# Access Compliance Report

## Public Rights-of-Way

### (Curb Ramps)

Intersection ID: 3337	Main Street: HUCKS_RD	Cross Street: SPRING_PARK_DR	Location: NE
ADA ID: 05AFA3EA92CB	Ramp Type: Perp	Initial Pass/Fail: Fail	Overall Compliance: No
		Severity Score: 22.5

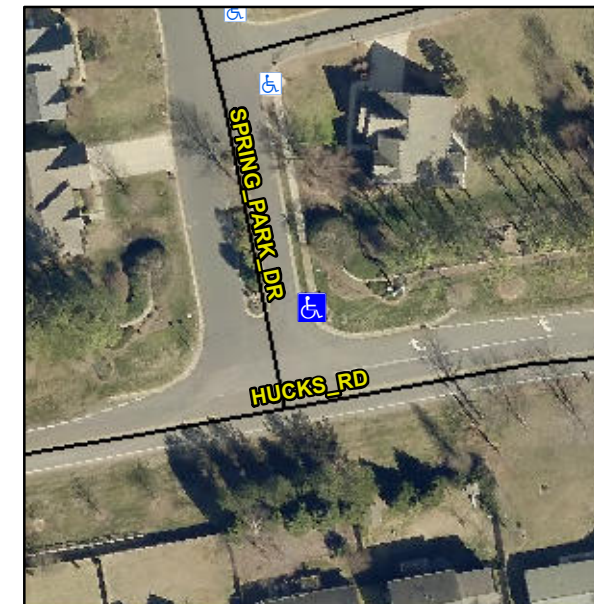
**Not Found, R304.5.1, R304.2.2, R304.5.3**

Compliance	Description	Data	Compliance	Description	Data
N/A	Ramp Length (in)	96.0	No	Ramp Slope (%)	8.5
No	Ramp Width (in)	37.5	No	Ramp XSlope (%)	5.0
N/A	Flare Type LT	N/A	N/A	Flare Type RT	N/A
N/A	Flare Slope LT (%)	N/A	N/A	Flare Slope RT (%)	N/A
N/A	Flare Traversable LT?	N/A	N/A	Flare Traversable RT?	N/A
N/A	Landing Length (in)	N/A	N/A	DWS Provided?	N/A
N/A	Landing Width (in)	N/A	N/A	DWS Contrast?	N/A
N/A	Landing Slope (%)	N/A	N/A	DWS Length (in)	N/A
N/A	Landing X Slope (%)	N/A	N/A	DWS Full Width?	N/A
N/A	Landing Curb? (Y/N)	N/A	N/A	DWS Offset (in)	N/A
N/A	Shared Landing?	N/A			
N/A	Gutter Ponding?	N/A	N/A	Gutter Slope (%)	N/A
N/A	Gutter Lip Ht (in)	N/A	N/A	Gutter X Slope (%)	N/A
N/A	Painted X Walk1?	No	N/A	Painted X Walk2?	N/A
	X Walk 1 Direction	To S		X Walk 2 Direction	N/A
N/A	X Walk 1 Width (in)	N/A	N/A	X Walk 2 Width (in)	N/A
	X Walk 1 Slope (%)	4.9		X Walk 2 Slope (%)	N/A
	X Walk 1 X Slope (%)	3.5		X Walk 2 X Slope (%)	N/A

**Remove & Replace Entire Ramp.**
